Agenda for 83rd PCCM

83rd Protection Coordination Sub-Committee Meeting

Date: 18/09/2025 (Thursday)

B.6 Grid Event at Sains 30th Aug'25 and 3rd Sep'25:

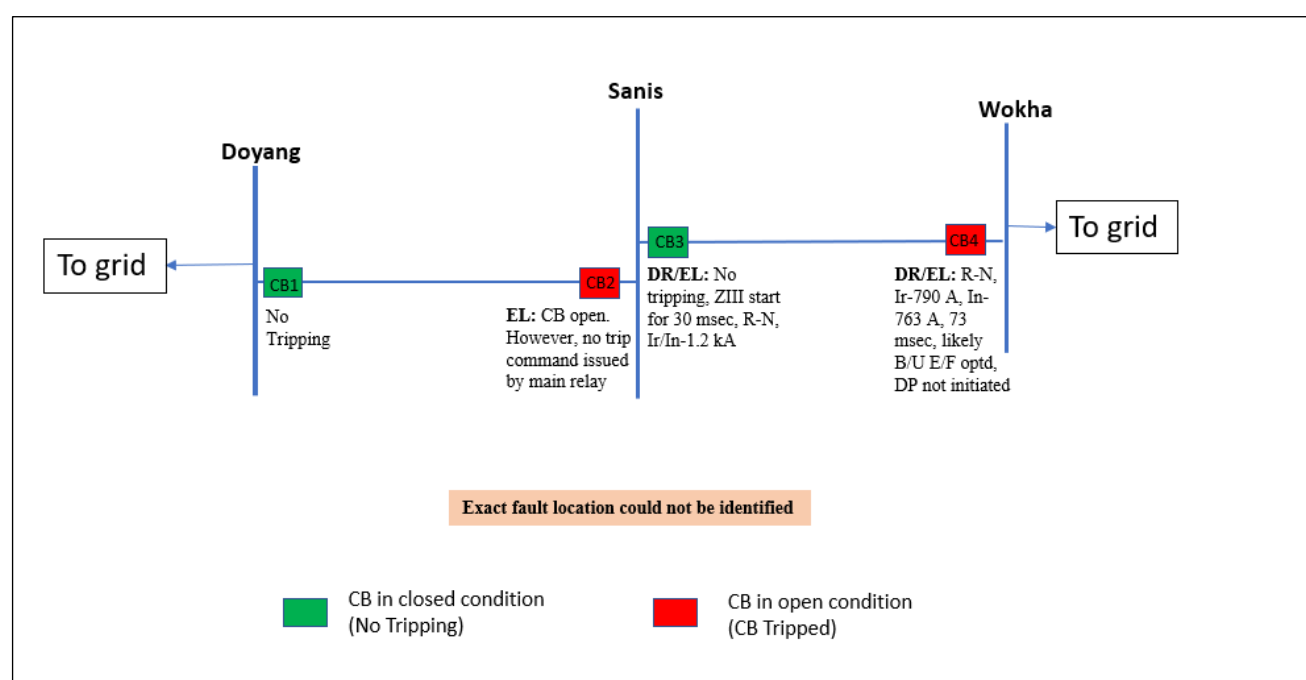
As per DR analysis for Wokha end (Main relay), R-N fault (Ir-790 A, In-763 A) initiated at 12:20:24.888 Hrs which was cleared 73 msecs from Wokha end likely on operation of B/U E/F protection (**DR & EL not submitted for backup relay**). Also, initiation of backup OC ($I >$) & EF ($In > 1$) protection observed in the main relay. Also,

From Sanis end (main relay), ZIII initiated for R-N fault (Ir-1280 A, In-1250 A) fault current disappeared within 30 msec likely after the CB opening at Sanis end of 132 kV Doyang- Sanis line. However, CB was closed as per submitted DR.

At 12:21:24.143 hrs, 132 kV Doyang-Sanis line tripped from Sanis end. As per the submitted EL (main relay) for Sanis end, no tripping command issued by the main protection. [DR&EL for backup relay not shared by DoP, Nagaland.](#)

Exact fault location could not be identified. However, the suspected fault seems beyond the Wokha substation as indicated by the ZIII initiation at Sanis end for 132 kV Sanis – Wokha Line.

- I. Share the exact fault location & root cause for the tripping.
- II. Share the reason for tripping of 132 kV Doyang-Sanis line from Sanis end for fault beyond the line (reverse direction) seems unwanted (newly commissioned on 20th Aug 2025).
- III. Share the reason for tripping of 132 kV Wokha-Sanis line from Wokha end for fault beyond the line (reverse direction) in 73 msec seems unwanted.
- IV. Healthiness of the backup relay need to be tested at Sanis & Wokha.
- V. DR downloading facility need to be implemented at Siemens relay at Sanis & Avana make relay at Wokha (otherwise relay replacement to be done).

B.7 Grid Event at Sains, Wokha, Chiephobozou & Zhadima area of Nagaland on 1st Sep'2025:

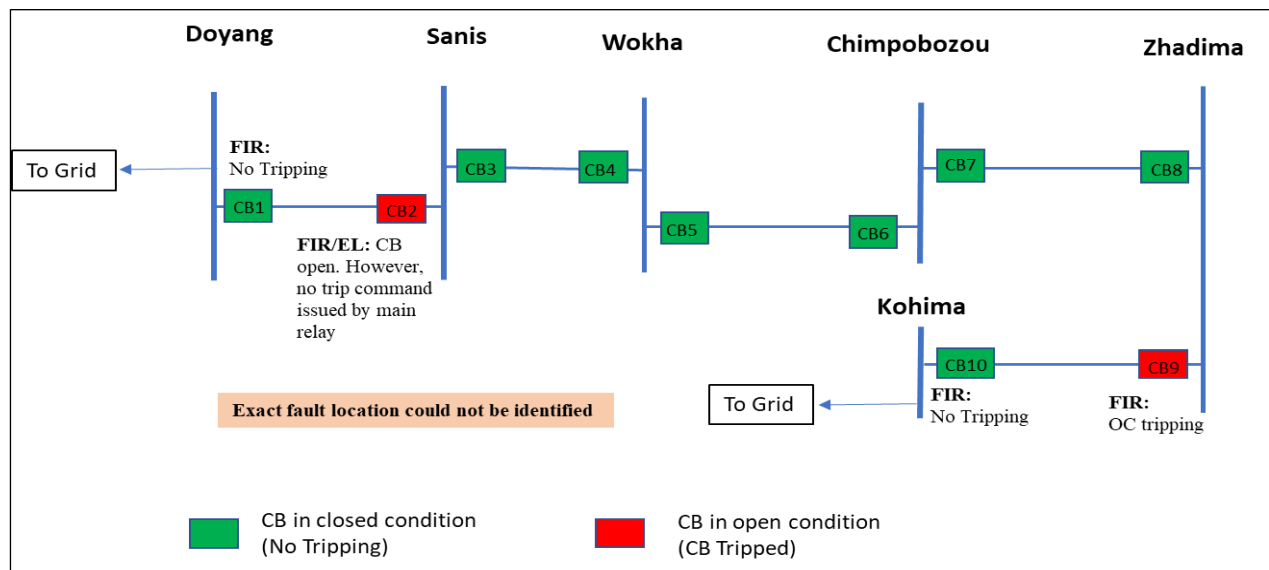
At 09:27 Hrs of 01-09-2025, 132kV Doyang-Sanis and 132kV Kohima - Zhadima line tripped. Due to tripping of these elements, Zhadima, Chiephobozou, Wokha and Sanis areas of Nagaland Power System were isolated from NER Grid.

- I. Share the exact fault location & root cause for the tripping.
- II. Share the reason for tripping of 132 kV Doyang-Sanis line from Sanis end for fault beyond the line (reverse direction) seems unwanted (newly commissioned on 20th Aug 2025).
- III. DR downloading facility need to be implemented at Siemens relay at Sanis & Avana make relay at Wokha (otherwise relay replacement to be done).

B.8 Frequent Tripping of Double-Circuit Lines in the Meghalaya Power System:

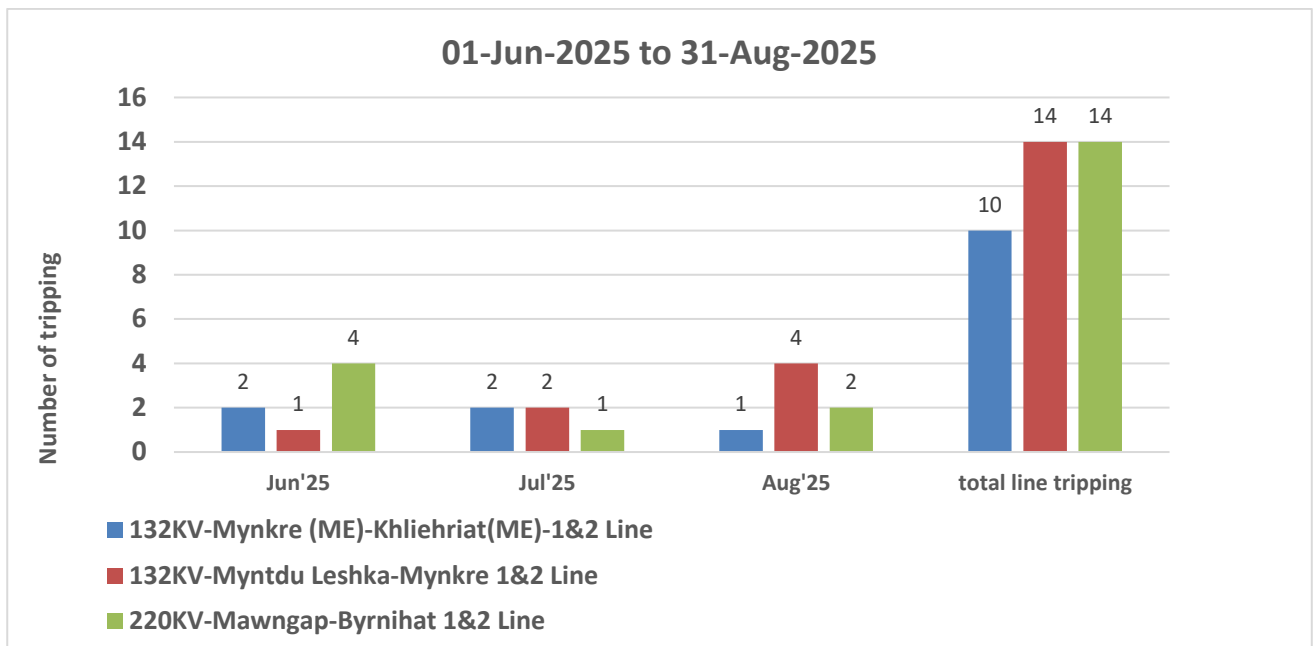
These 3 Double circuit lines tripped total 38 times during the period 01-Jun-2025 to 31-Aug-2025 hampered reliability of the Meghalaya power system of NER. Also, all those events resulted into the Grid Disturbance at the Meghalaya power system. The majority of tripping occurred in 132KV-Mynkre (ME)- Khliehriat (ME)-1 &2 line and 132KV-Myntdu Leshka - Mynkre 1&2 Line caused due to Vegetation & lightning resulted into back flashover resulted into multi-Phase to ground fault which also impacting 128 MW Leshka generation.

Also, majority of tripping occurred in 220KV-Mawngap-Byrnihat 1&2 Line caused due to lightning resulted into back flashover resulted into multi-Phase to ground fault.

- **Adequate RoW width:** Ensure adequate corridor for clearance, maintenance, and safety
- **Overhead Ground Wires (Shield Wires / Earth Wires):** To be placed above phase conductors so as to intercept lightning strokes and safely divert lightning currents to ground.

- **Low Tower Footing Resistance (TFR):** Ensure that tower footing resistance is maintained below ~10 ohms for effective dissipation of lightning current into the ground.
- **Transmission Line Surge Arresters (TLSA):** To be installed on selected towers, especially in high lightning density zones or on critical line sections, to effectively clamp overvoltages and prevent flashovers.

B.10 GD at Rangia and radially fed areas including Bhutan system on 5th Aug'25:

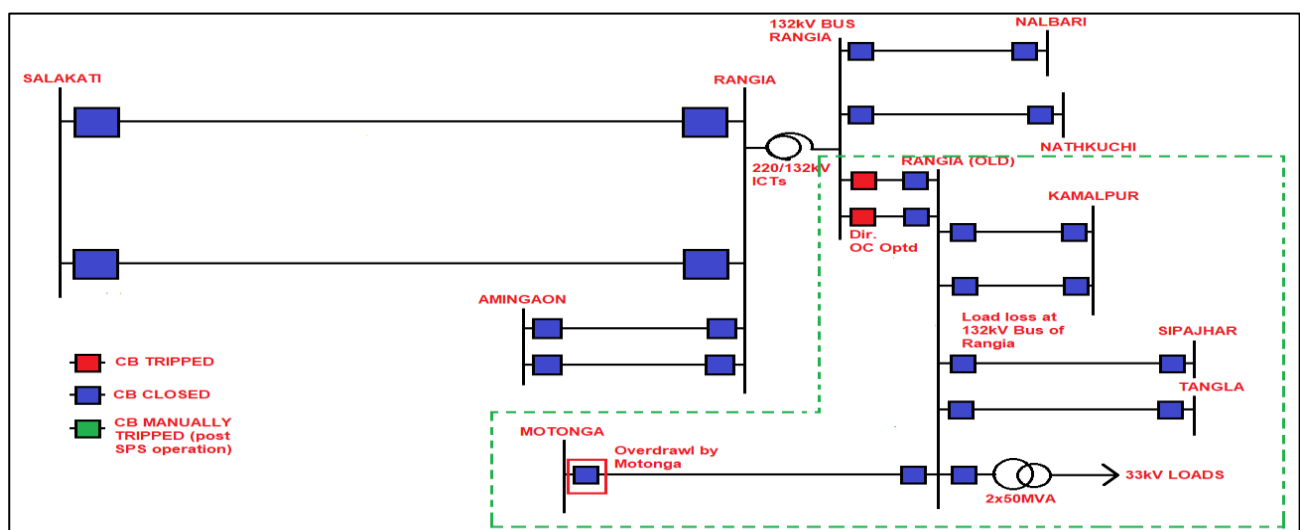
There was no fault observed in the system and the 132 kV Rangia-Rangia(old) DC line tripped on operation of Overcurrent protection due to overloading of the lines. Due to sudden rise in power drawl by 132 kV Motonga feeder due to opening of 132 kV Jigmeling - Tinbiti line in Bhutan, the load in each 132 kV Rangia-Rangia(old) short line increased to 80 MW each. CBs of the short lines at 132 kV Rangia tripped on Directional OC protection.

Hence, AEGCL is requested to kindly review the Overcurrent (O/C) relay pickup setting, as the relay operated at a fault current of 380–410 A, whereas the pickup setting was maintained at 440 A.

Also, explore the possibility of increasing the overcurrent settings for the short lines.

B.11 Tripping of multiple elements at 220 kV Agia substation of Assam on 14-08-2025:

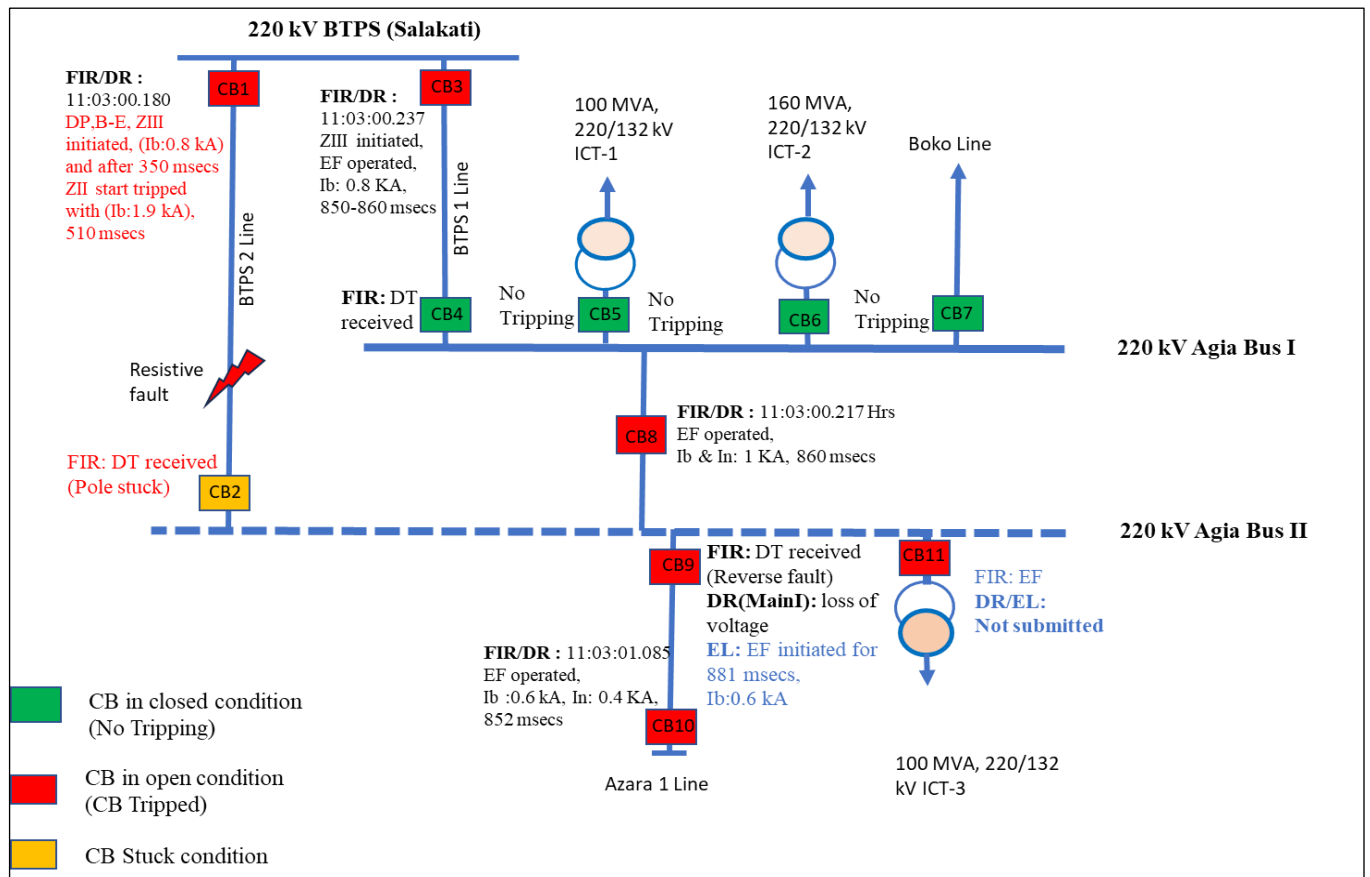
High resistive fault observed in the 220 kV Agia – BTPS II line, cleared from BTPS end by the DP, ZII protection within 510 msecs. Also send DT signal to Agia end. However, the CB got stuck at Agia for the same line.

LBB relay not initiated during the fault at Agia Bus II.

The fault was cleared from the system by tripping of 220 kV Agia – BTPS I line, Bus Coupler & 220 kV Agia–Azara Line in 850-860 msecs.

Also, the fault persisted in the system for 1670 msecs and finally cleared by tripping of ICT-3 which causes the blackout of Bus II at Agia SS.

1. Share the reason for non-operation of LBB relay for Agia Bus II.
2. Share the reason for EF pickup at Agia end for 220 kV Agia - Azara Line & ICT-3.
3. Share the reason for DT sent (as informed verbally) from BTPS end for ZII tripping.
4. DT received & DT sent need to be incorporated in the DR for each element.

B.12 Frequent tripping of 132 kV Loktak - Rengpang line (July'25 – 8th Sep'25):

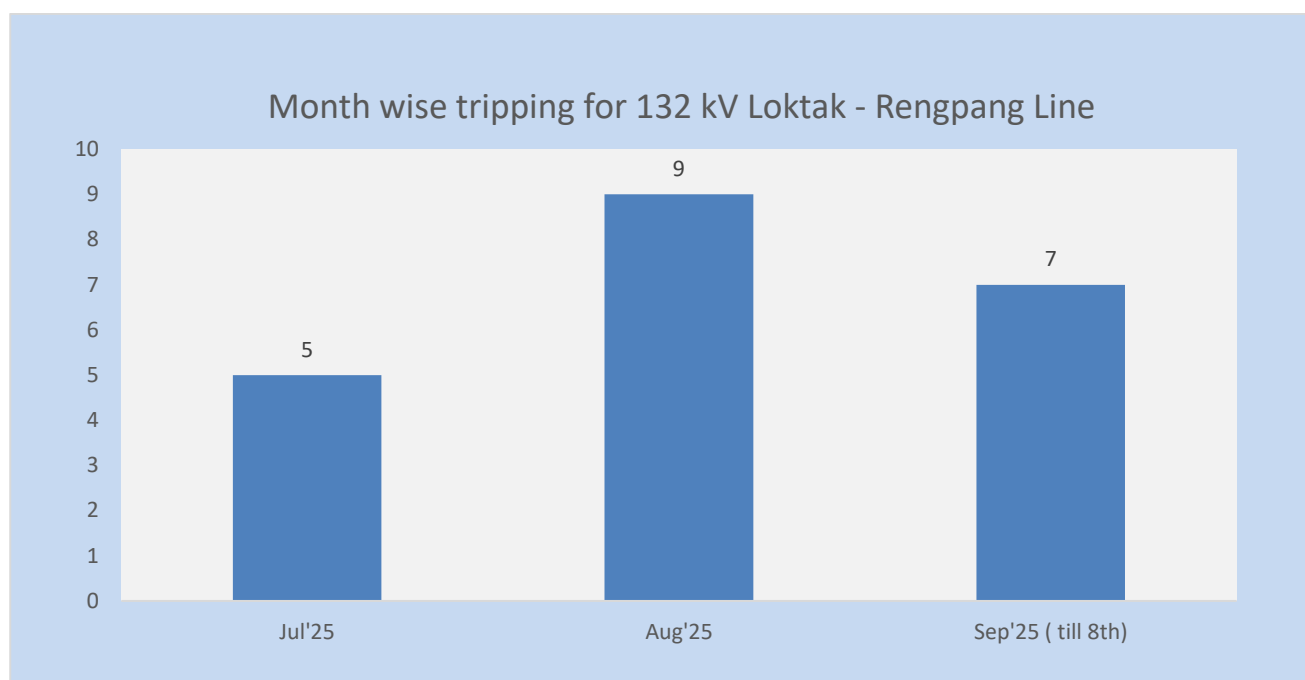
Tripping of 132 kV Loktak – Rengpang line observed in 31 instances starting from July'25 onwards. Also, 7 times during the 1st Sep-8th Sep'25 indicates serious maintenance issues.

As per DR & EL data, most of the tripping caused due to high resistive fault in B-phase across the line length likely due to vegetation causing the frequent Grid Disturbance at Manipur which causing stress to machines at Loktak (NHPC) power station.

Hence, MSPCL is requested to exercise periodic maintenance for reducing the tripping of the line.

B.13 Grid event at multiple areas of the Manipur on 5th Sep'25:

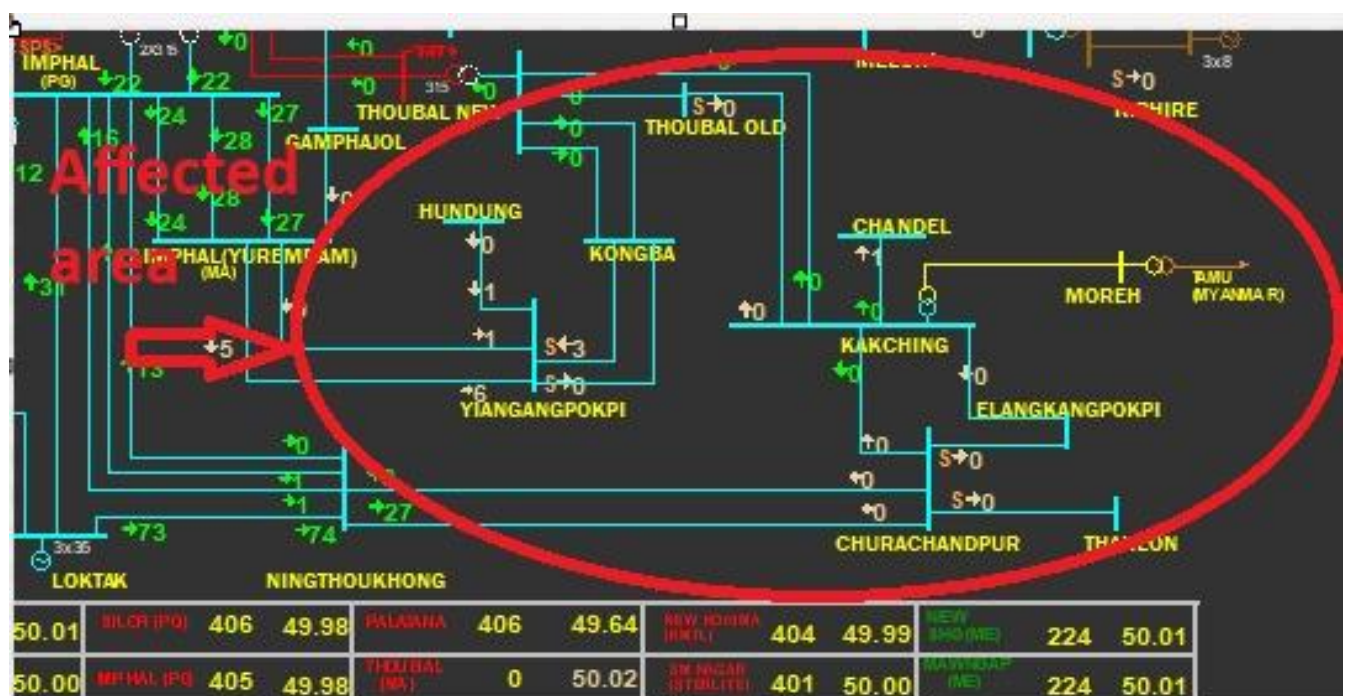
The exact sequence of event could not be identified due to lack to numerical relay for backup protection at Ningthoukhong.

However, as per the DR snapshot for the Imphal end of 132 kV Imphal-Yiangangpokpi I line, balance current observed which indicated no fault present in the system.

Also, fault current in each phase of 220 -225 A (approx. 50 MW) suddenly increases to 445-450 A (approx. 100 MW) probably due to the tripping of 132 kV Ningthoukhong-Churachandpur 2 line.

- I. Requirement of the testing of the static relay at Ningthoukhong to check the healthiness (as per setting relay should not have operated due such loading). Also, static relays to be replaced with numerical type as early as possible.
- II. Backup setting need to be incorporated in the main to cross verify the performance of the backup OC, EF relay (static relay) at Ningthoukhong.
- III. Overloading setting need to be revised for 132 kV Imphal – Yiangangpokpi 1 line (currently pickup current: 300 A only).
- IV. Time drift of 1 hr observed in the DR of Yurembam (Imphal). The same need to be matched.
- V. Time synchronizer need to installed at Imphal & Ningthoukhong as early as possible.

C.1 Grid Disturbance in Mynkre area and Leshka HEP of Meghalaya Power System on 1st June'25:

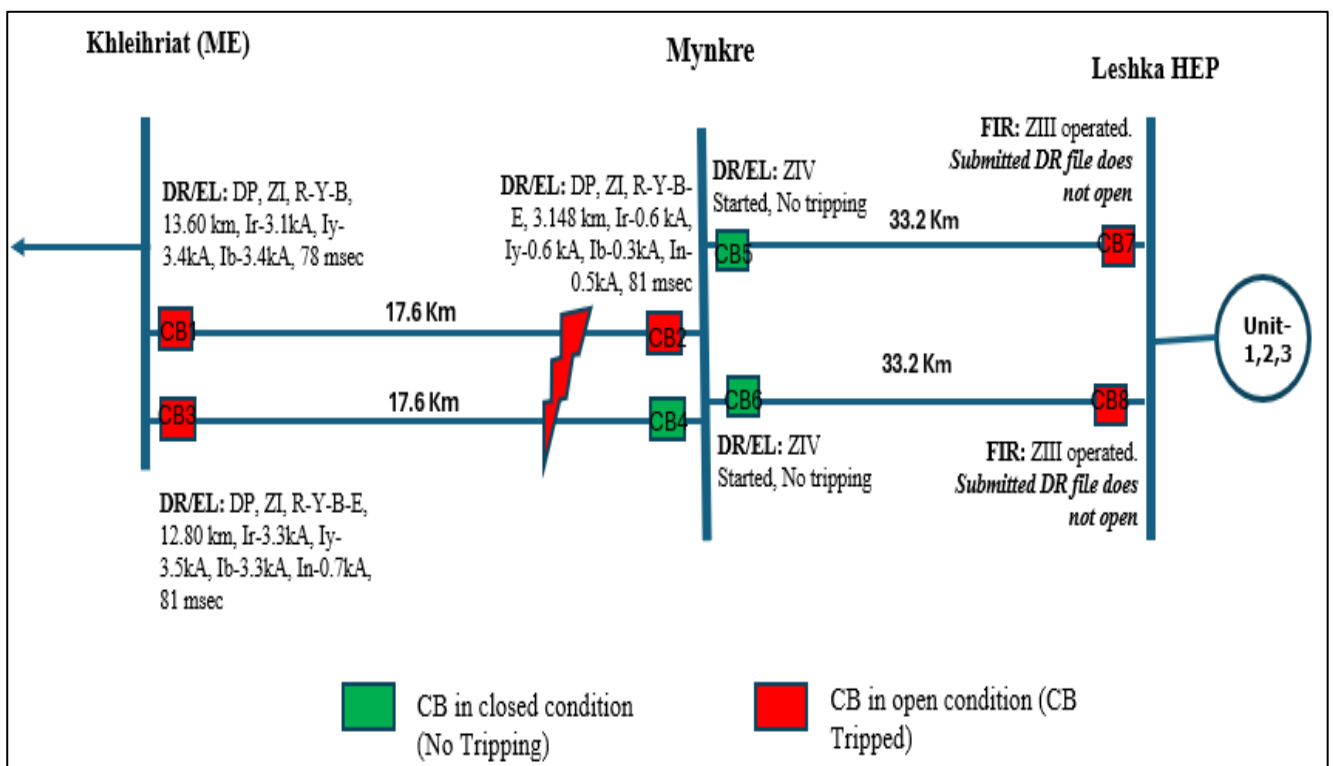
- Protection system of Mynkre (ME) of 132kV Mynkre (ME)-Khliehriat(ME)-2 line failed to isolate the fault which led to clearing of the same fault by tripping of healthy 132 kV Mynkre-Leshka D/C lines from Leshka end on ZIII operation.
- Time drift of 7 mins (lag) in submitted DRs from Mynkre end for 132kV Mynkre (ME)-Khliehriat(ME) 1 line & 13 mins (lag) in submitted DRs from Mynkre end for 132kV Mynkre-Leshka D/C lines which needs to be rectified.

As per 81st PCC minutes, MePTCL informed that fault was due to lightning. Regarding non-opening of CB at Mynkre end for 132 kV Khliehriat-II line, relay testing to be done by MePTCL. Also, MePTCL informed that GPS was rectified on 16th July'25.

C.5 (Agenda B10, 81st PCC) Grid Disturbance in Ningthoukhong area of Manipur Power System on 9th June'25:

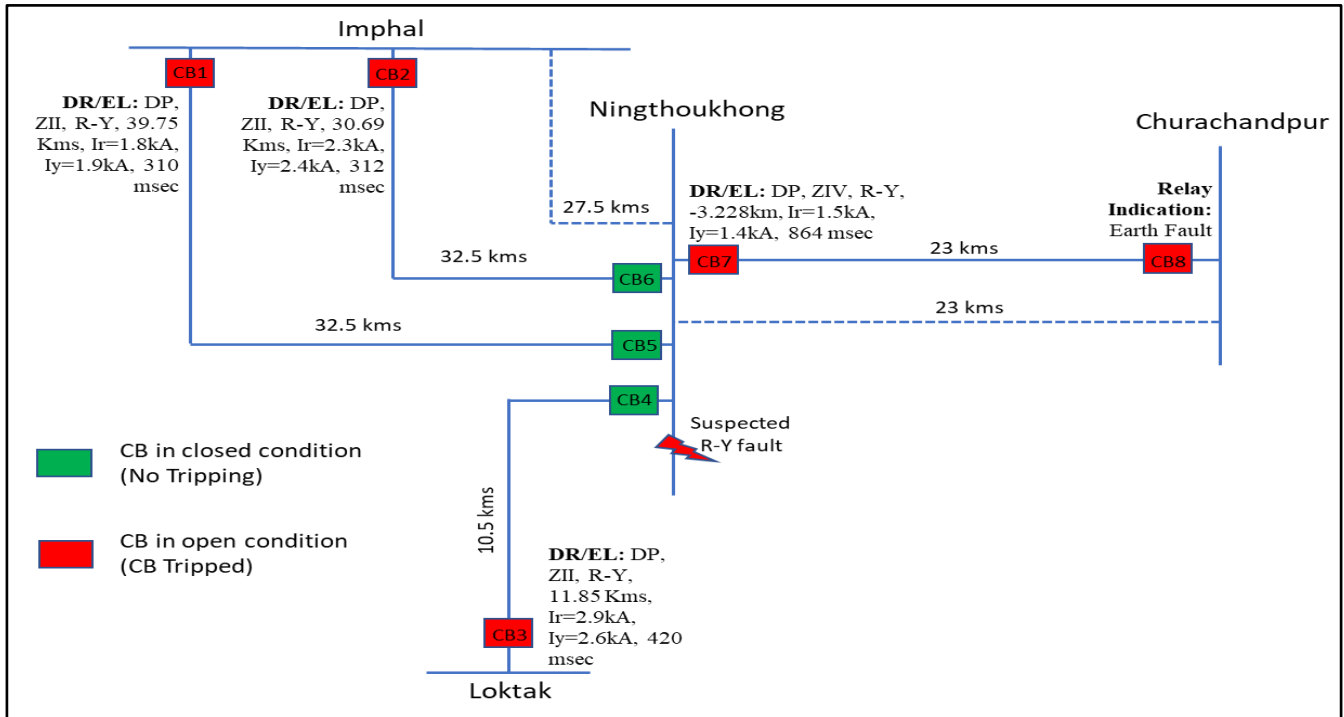
- Suspected fault was either in 132 kV Ningthoukhong S/S or downstream of Ningthoukhong as Z4 trip from Ningthoukhong end for 132 kV Churachandpur end indicating fault in reverse direction.
- It is not clear which protection system operated at Churachandpur end and cleared the fault due to non-availability of DR/EL.
- Non-submission of DR/EL file for CB4, CB5, CB6 & CB8 which is a violation of Clause 37.2 (c) IEGC-23.
- Non-submission of detailed report of the event which is a violation of Clause 37.2(e) of IEGC-23.

Manipur informed that the fault was in Imphal-Ningthoukong line 3 at a distance of 3 Km from Ningthoukhong end. NERLDC stated that CB6 should have operated. Further NERLDC stated that the complete analysis of the event could not be done due to non-submission of DRs by MSPCL. Forum asked Manipur to submit the DRs of CB4, CB5, CB6 & CB8 for facilitating complete analysis. Forum urged MSPCL to thoroughly investigate the event and submit a detailed analysis report of the event.
